GRACE PARK

AN ADDITION TO WICHITA, SEDGWICK COUNTY, KANSAS

RE: SUB 2002-132 -- Final Plat of Grace Park Addition

CASE NUMBER: SUB 2002-132 -- GRACE PARK ADDITION

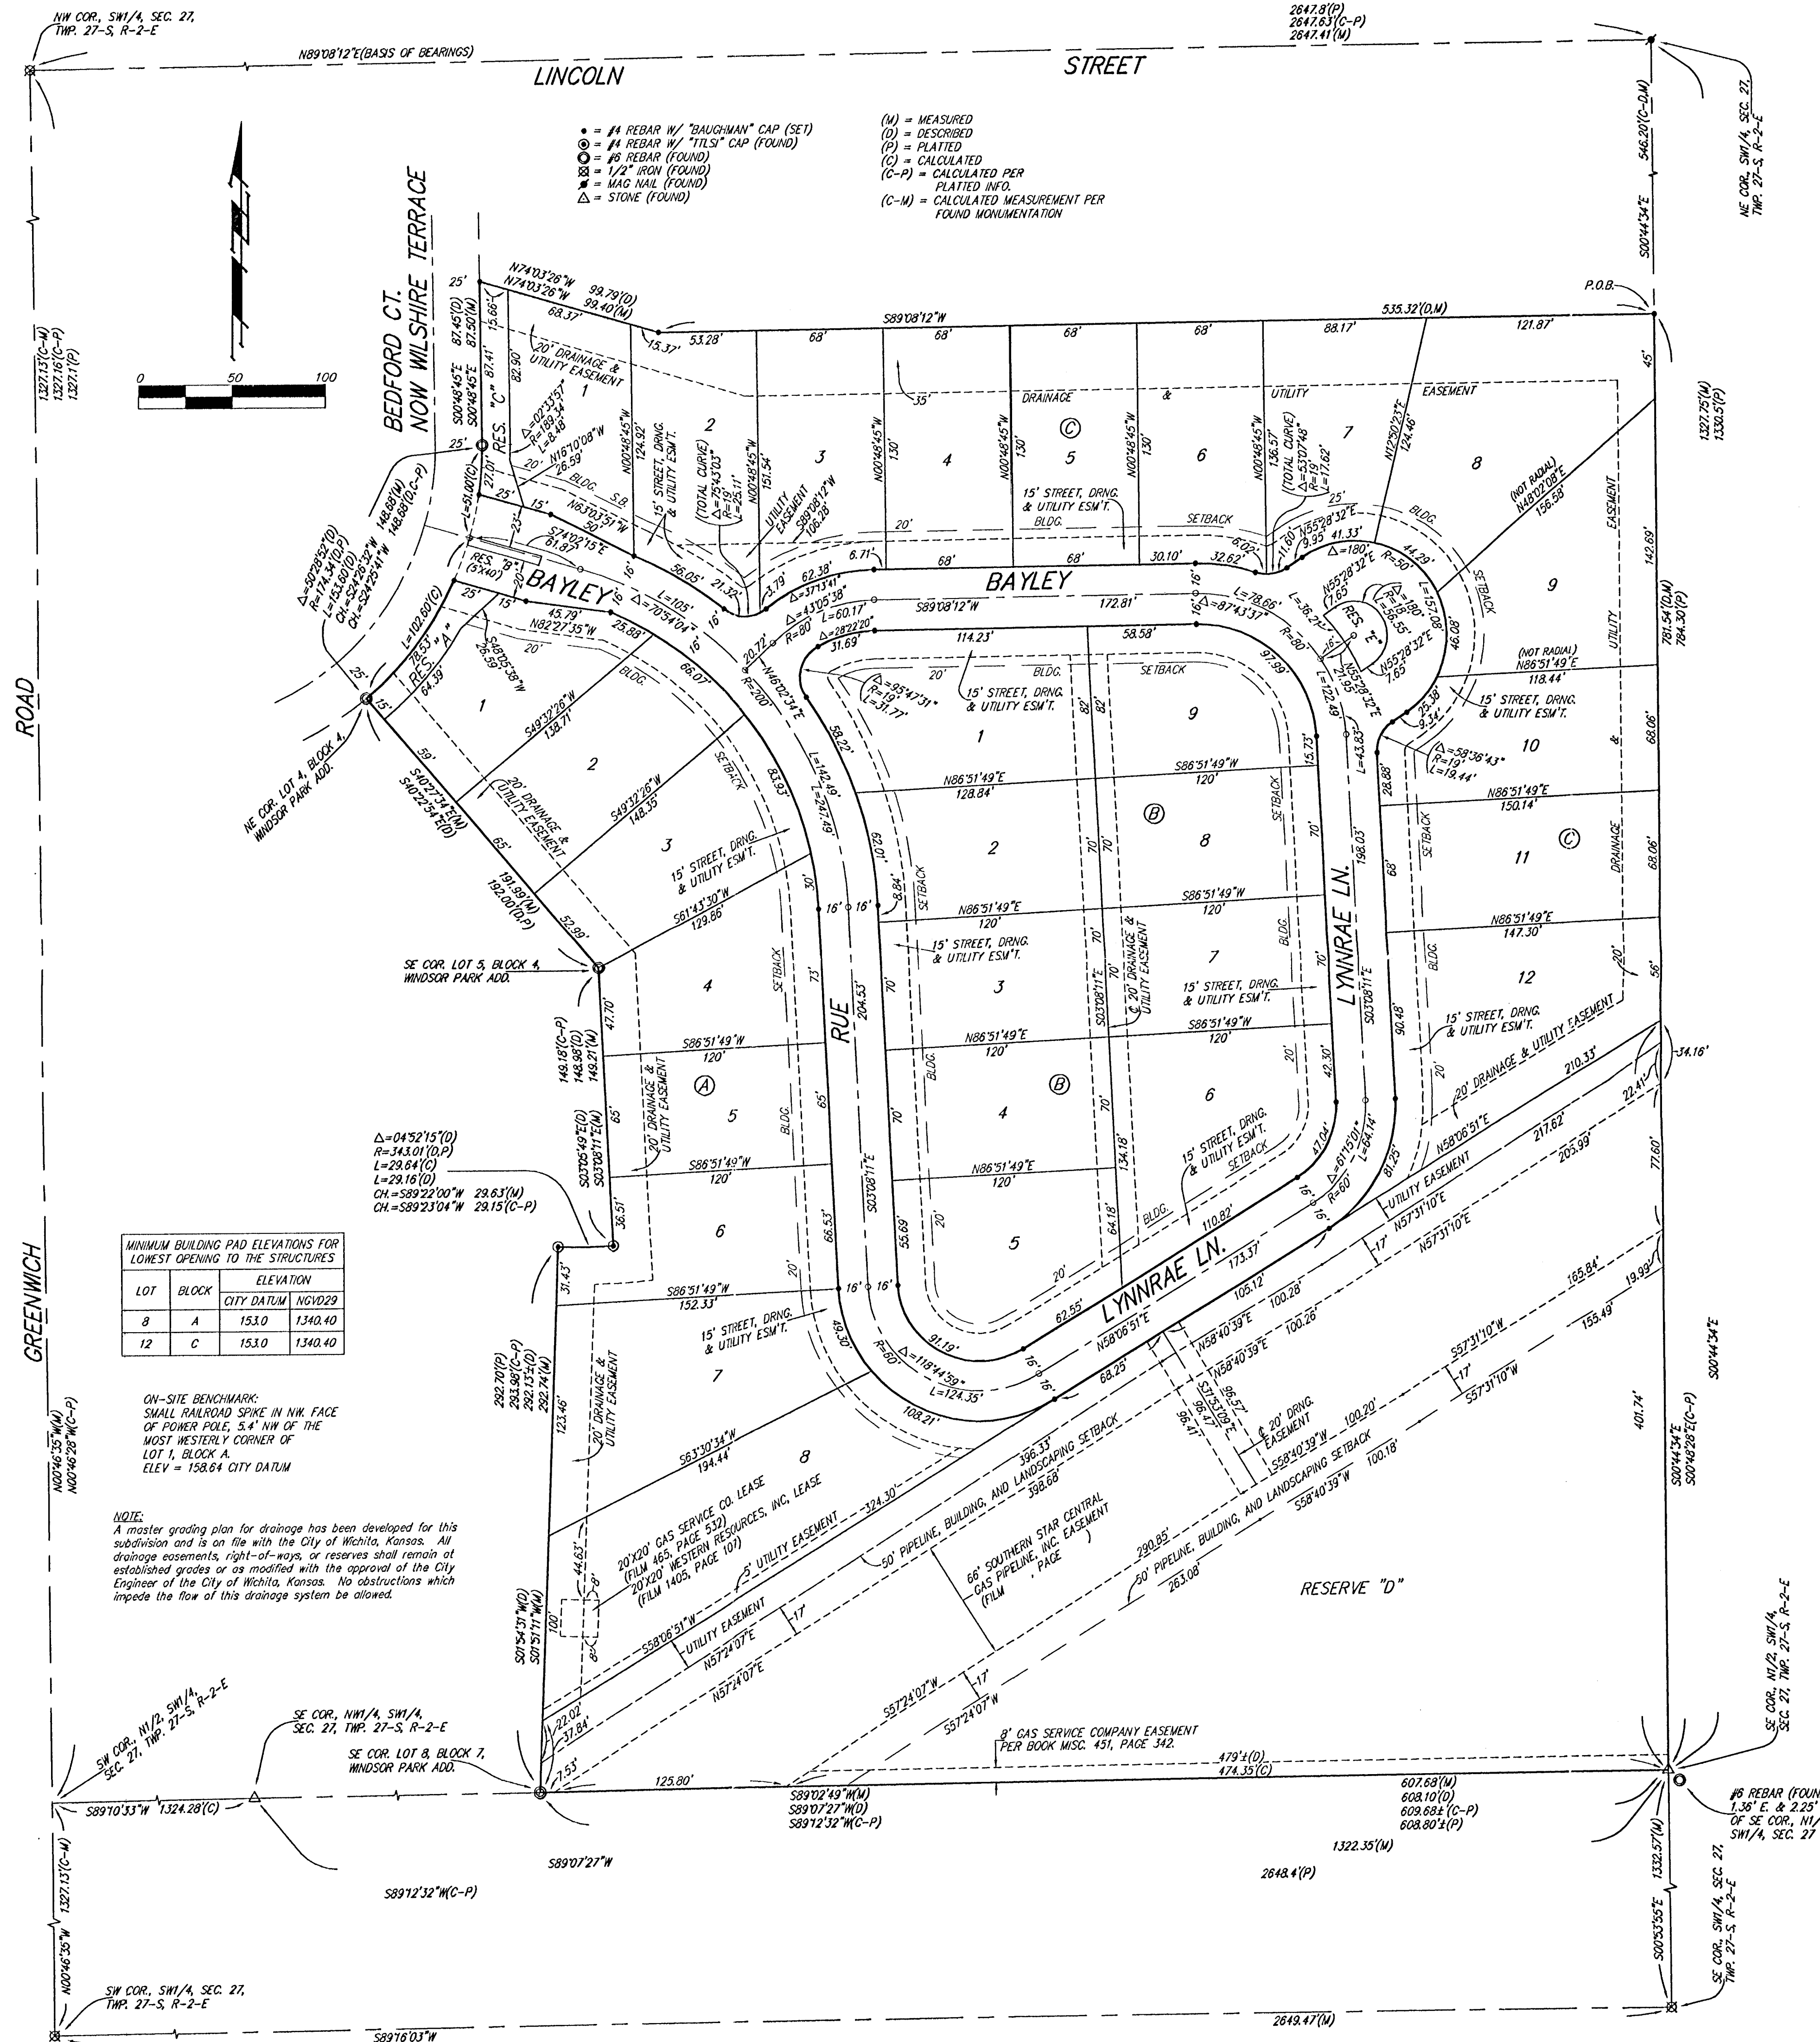
- C. An off-site right-of-way dedication shall be submitted connecting Bedford to Lincoln.
- D. City Engineering has approved the drainage plan.
- E. Direct access from this site through Windsor Park to the west will be eliminated through the following: 1) the applicant shall construct a hammerhead turnaround for Bedford Ct south of the entrance to the site, 2) the applicant shall construct a circular turnaround for Bedford Ct just south of Lincoln.

- F. City Fire Department has requested an emergency access easement from one of the turnarounds. Standard gating and signing are required per City Fire Department standards.

- H. Since this plat proposes the platting of narrow street right-of-way with adjacent "15-foot street drainage and utility easements", a restrictive covenant shall be submitted which calls out restrictions for lot-owner use of these easements. Retaining walls and change of grade shall be prohibited within these easements as well as fences, earth berms and mass plantings.

- J. The Blocks shall be relabeled as A and B.
- K. 20'x20' gas lease area needs located on plat.
- L. Approval of this plat will require a waiver of the lot depth to width ratio of the Subdivision Regulations for Lot 8, Block A. The Subdivision Regulations state that the maximum depth of all residential lots shall not exceed 2.5 times the width. The Subdivision Committee has approved the modification.

- M. GIS has requested that Bedford Ct be revised to Wilshire Ter.
- N. The platting binder indicates a party holding a mortgage on the site. This party's name must be included as a signatory on the plat, or else documentation provided indicating that such mortgage has been released.

- P. The applicant's agent shall determine any setback requirements for the pipelines by researching the text of the pipeline agreements. If a setback from the pipeline easements is provided for in the pipeline easement agreements, it shall be indicated on the face of the plat.

- Q. For any lots with existing tree rows that may be impacted by the installation of utilities, it is recommended that 30-ft utility easements be platted in order to allow for the installation of the utilities without damage to such tree rows.
